RE: Rochester Housing Authority,
Exterior Improvements-Jonathan Child

Jonathan Child

Exterior Improvements

Addendum #1

ASK-2

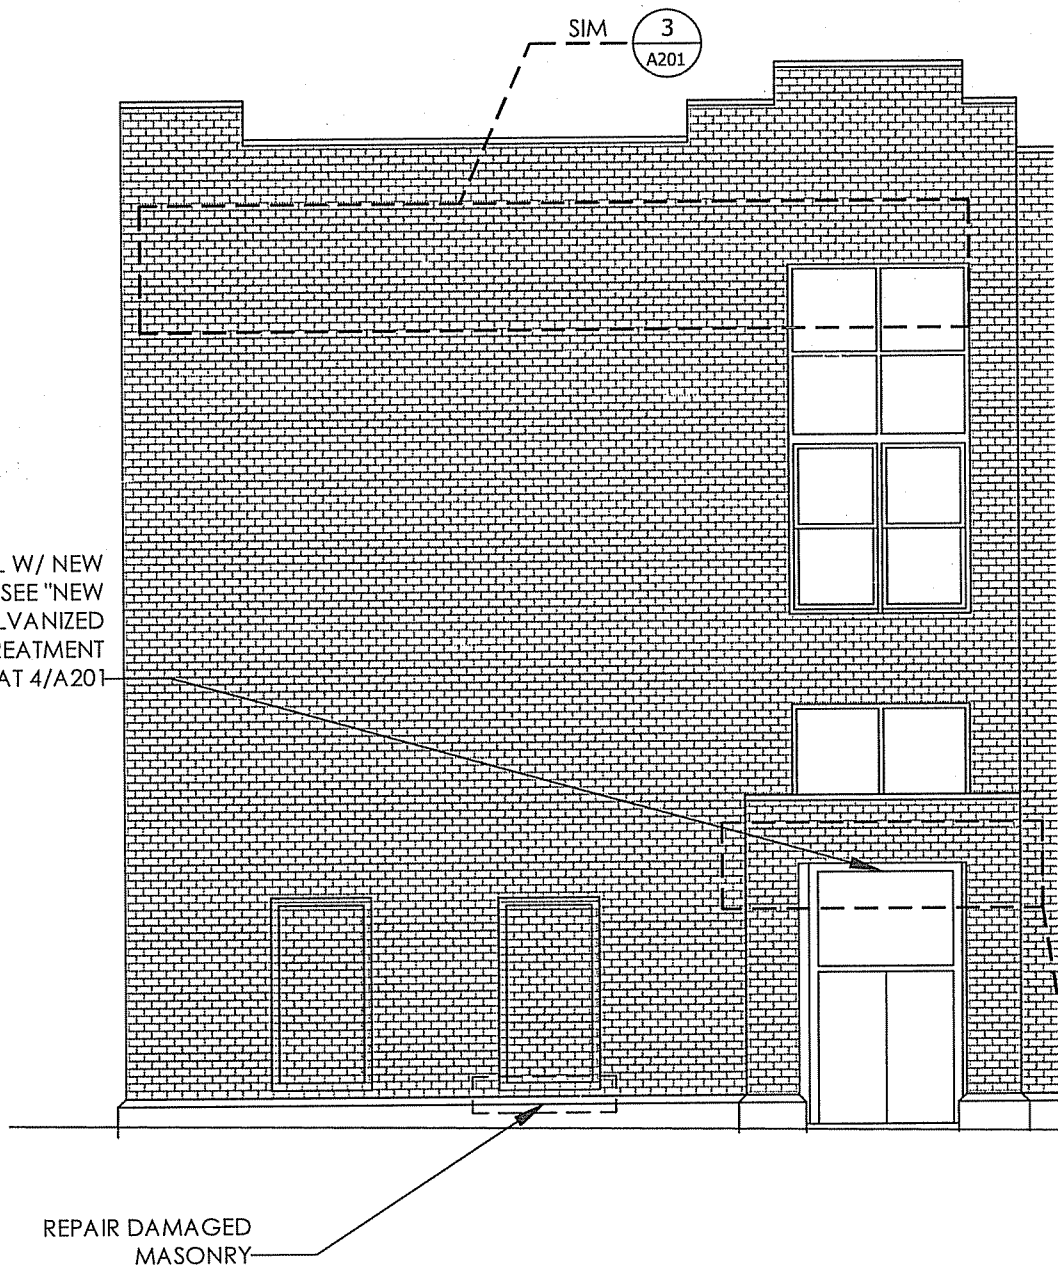
- 3 LINTEL DEMOLITION CLARIFICATION
In the contract drawings, Drawing No. 5/D100; **DELETE** the information in drawing 5/D100 in the bid documents; **INSERT** the information in the attached ASK-2.

LINTEL DEMOLITION NOTE

SHORE WALL ABOVE LINTEL PRIOR TO DEMOLITION SEE 3/D100

REMOVE EXISTING LINTEL

JOB
NO. 1529
DWG. NO.
ASK-3

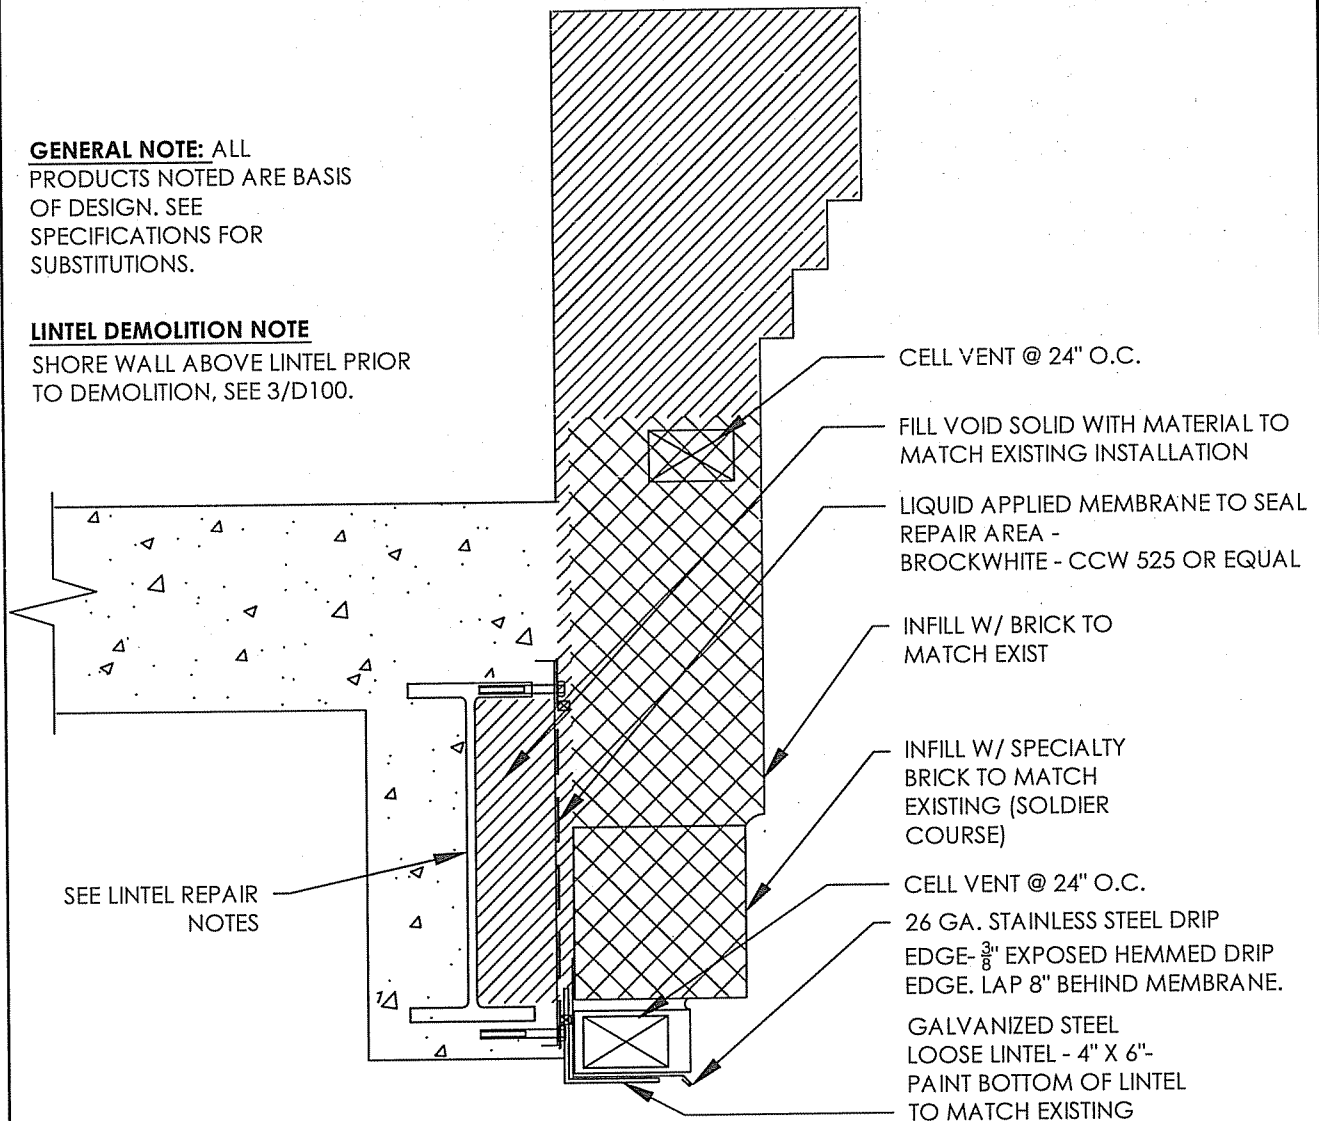
- 4 ADDITIONAL INFORMATION FOR LINTEL REPLACEMENT CALLOUT.
In the contract drawings, Drawing No. 5/A200: **INSERT** the additional note in the attached ASK-3.

REPLACE 3 PIECE LINTEL W/ NEW GALV. STEEL LINTELS; SEE "NEW EXTERIOR EXPOSED GALVANIZED LOOSE LINTEL TREATMENT PROCEDURE" NOTE AT 4/A201

JOB NO. 1529
DWG. NO.
ASK-4

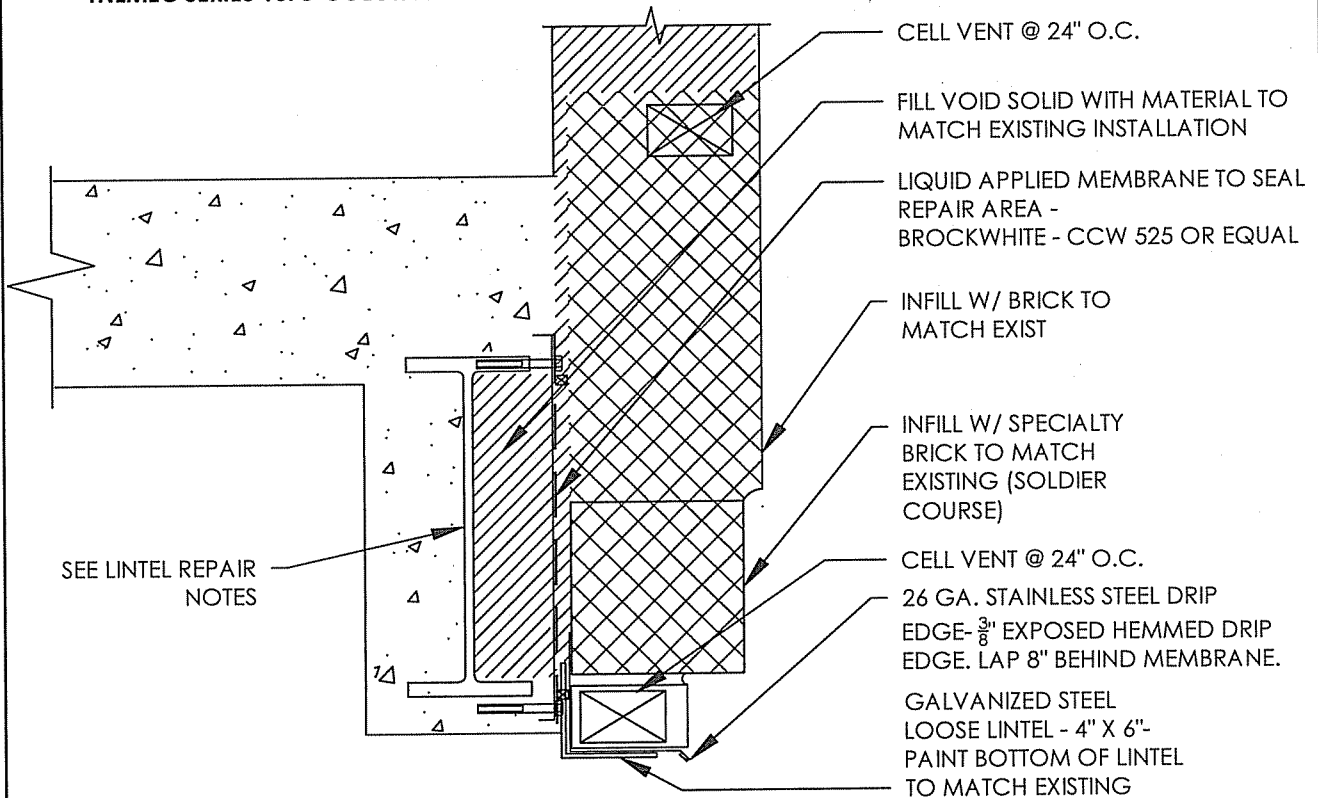
- 5 ADDITIONAL INFORMATION FOR LINTEL REPLACEMENT CALLOUT.
In the contract drawings, Drawing No. 4/A201: **INSERT** the additional information in the attached ASK-4 & ASK-5.

- CELL VENT @ 24" O.C.
- FILL VOID SOLID WITH MATERIAL TO MATCH EXISTING INSTALLATION
- LIQUID APPLIED MEMBRANE TO SEAL REPAIR AREA - BROCKWHITE - CCW 525 OR EQUAL
- INFILL W/ BRICK TO MATCH EXIST
- INFILL W/ SPECIALTY BRICK TO MATCH EXISTING (SOLDIER COURSE)
- CELL VENT @ 24" O.C.
- 26 GA. STAINLESS STEEL DRIP EDGE- $\frac{3}{8}$ " EXPOSED HEMMED DRIP EDGE. LAP 8" BEHIND MEMBRANE.
- GALVANIZED STEEL LOOSE LINTEL - 4" X 6"- PAINT BOTTOM OF LINTEL TO MATCH EXISTING

SEE LINTEL REPAIR NOTES

ASK-6

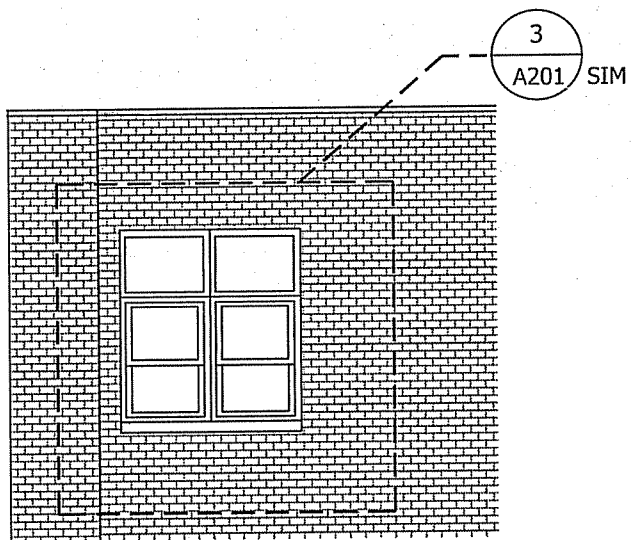
- 6 ADDITIONAL INFORMATION FOR TREATING EXPOSED LINTELS.
In the contract drawings, Drawing No. 1/A201: **INSERT** the additional information in the attached ASK-6.

EXPOSED STEEL SURFACES:

SURFACE PREPARATION:
SSPC SP11 POWER TOOL CLEAN TO BARE METAL. ALL SURFACE CLEAN AND DRY.

PRIME COAT:
SERIES 1 OMNITHANE @ 2.5 - 3.5 MILS DFT

INTERMEDIATE COAT:
TNEMEC SERIES N69-COLOR HI-BUILD EPOXOLINE II @ 3.0 TO 5.0 MILS DFT

FINISH COAT:
TNEMEC SERIES 1075-COLOR ENDURA-SHIELD II @ 2.0 TO 3.0 MILS DFT

TREAT EXPOSED LINTELS PER PROCEDURE STATED ABOVE

ASK-7

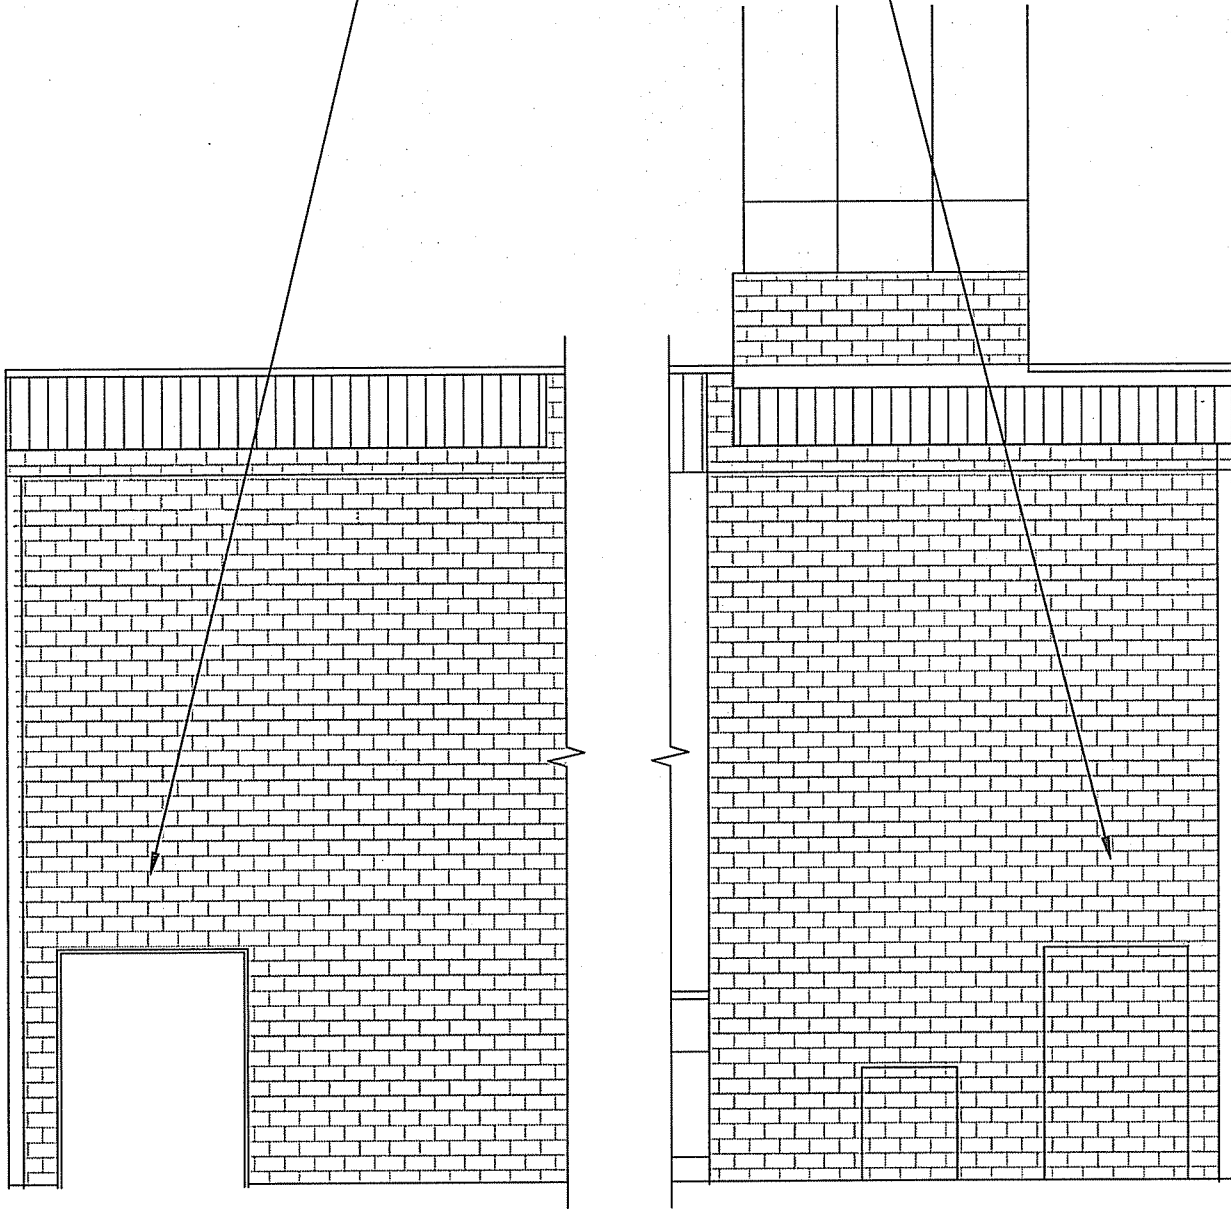
- 7 ADDITIONAL CALLOUT 3/A201 - TO MATCH DEMOLITION DRAWINGS
In the contract drawings, Drawing No. 2/A201; **INSERT** the information in the attached ASK-7.

ASK-8

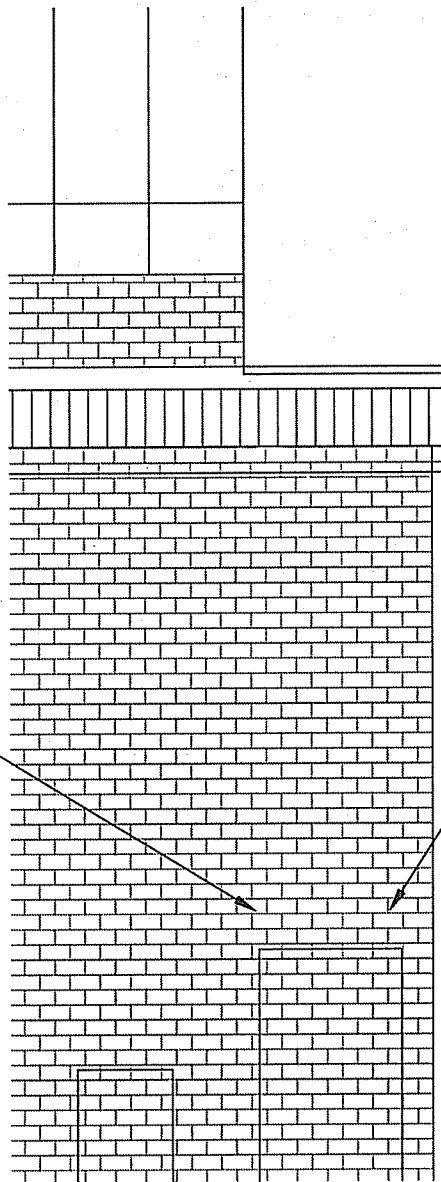
- 8 REDUCE STEPCRACKING AREA
In the contract drawings, Drawing No. 4/A202; **DELETE** the stepcracking note in the original bid documents and **INSERT** the information in the attached ASK-8.

REPAIR SIGNIFICANT STEP CRACKING
(25 SF EACH WALL).
SEE STEP CRACKING NOTES.

ASK-9

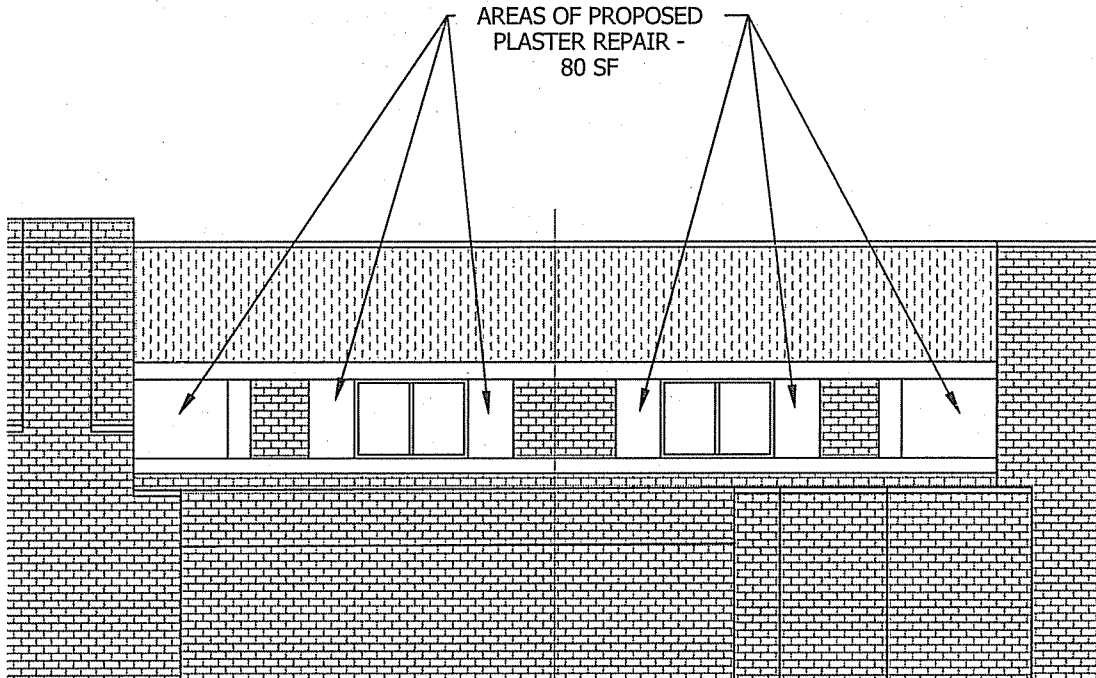
- 9 BRICK REMOVAL AND REPLACEMENT
In the contract drawings, Drawing No. 4/A202; **INSERT** the information in the attached ASK-9.
- 10 AREAS OF PROPOSED PLASTER REPAIR
In the contract drawings, Drawing No. 2/A201; **INSERT** the plaster repair shown in the attached ASK-10, into the elevation.

DEMO: REMOVE
BRICKS, STEEL
LINTEL. PREPARE
FOR INFILL

PROPOSED: INFILL
W/ BRICK ONLY (NO
LINTEL NECESSARY)
